Highways England: A303 Amesbury to Berwick Down Project, Development Consent Order Application

Scheme Reference: TR010025

Response to Highways England's Document
"8.44 - Comments on any further information
requested by the ExA and received at Deadline 5
and 6" (REP 7-021)
Inquiry Reference TR010025-001438
for

The Stonehenge Alliance (Reference No. 2001870)

Figure 2 Chalk Stratigraphy with Tunnel and Chalk Rock Elevations (adapted from Mortimore 2012)

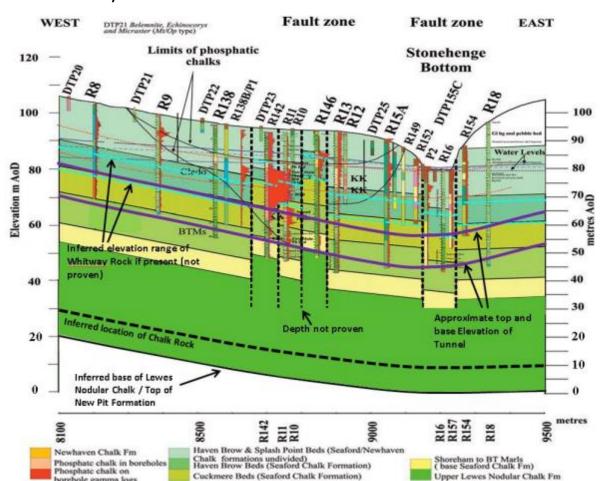
The Stonehenge Alliance suggests there is evidence to show that the Whitway Rock horizon **is** present and not entirely above the tunnel elevation: this could substantially change the situation as given by Highways England. Clarity on this issue is vital to the viability of the Scheme and to those areas affected by groundwater movement.

"If the crown of the tunnel is located below the Stockbridge Rock in Stonehenge Bottom, i.e. at approx. 25m BGL (55mAOD), with the road level in the tunnel at 36.3m AOD, the tunnel would be approximately 15m deeper than is currently shown in Highways England drawings. The current levels shown in the drawings (HEng. DCO Application: Documents 2.7- Engineering Section Drawings; No.7 of 24 [App-010]) show the crown level of the tunnel below Stonehenge Bottom at 70m AOD, and the road level at 51.3mAOD."
